Access Compliance Report Public Rights-of-Way (Pedestrian Signals)

Intersection ID: N/A	Main Street:	Cross Street: N/A	Location: N/A
ADA ID: 53053164088A	Signal Type: One Push Button-Non APS	Overall Compliance: No	Severity Score: BTN 1: N/A BTN 2: N/A No BTN: N/A
Codes/Mitigation Info/Possible Solution		Field Measurements/Component Compliance

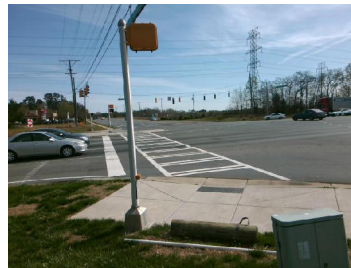
PROW/ADA: TMUTCD 4e.08, R404.2, R404.3, R404.7.3, R404.7.2

Possible Solutions: Replace Signal Push Button With APS Button on New Post. Remove & Relocate Sign.
